173-179 Walker Street and 11-17 Hampden Street, North Sydney SSD-67175465 | Public Exhibition Submission | Objection

This letter provides a formal objection to the State Significant Development Application (SSDA), referred to as SSD-67175465.

Figure 1 Sites considered in the VIA (with 45 McLaren Street outlined in yellow)

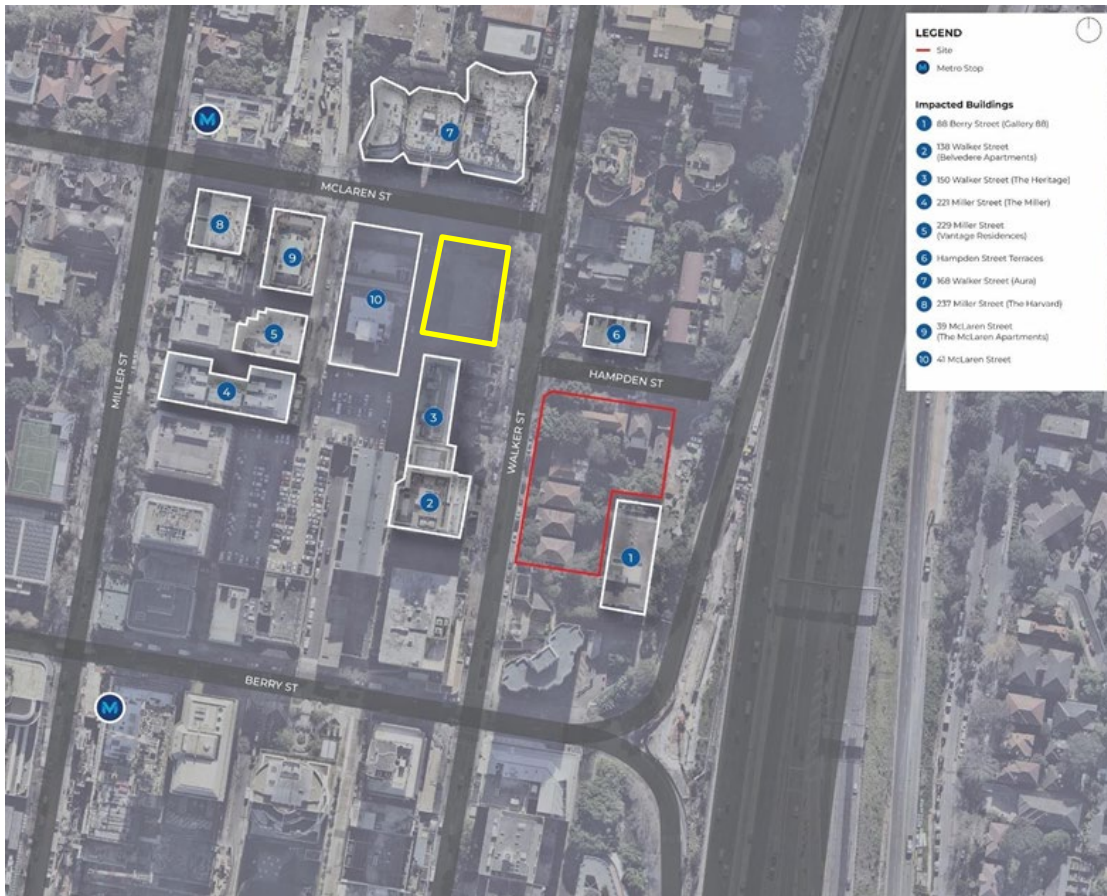
As illustrated in Figure 1 below, the VIA prepared by Ethos Urban, identifies buildings within the immediate visual catchment which may be impacted by the proposed development. It is evident that 45 McLaren Street has been omitted from the VIA assessment.

Whilst the current building on site is only 4 storeys, planning for the site at 45 McLaren Street has been ongoing and well documented. The submitted Urban Design Report includes the now approved building envelope for 45 McLaren Street, and thus it should have been considered in the VIA.

It appears that this was an error in the technical analysis of the VIA. Until such time that a VIA is undertaken, based on the stamped approved plans for 45 McLaren Street, an assessment of the visual impacts is unable to be undertaken.

Objection: The VIA is to be updated to include an assessment of the visual impacts on the approved development at 45 McLaren Street. This is to be based on actual approved RLs for the site.
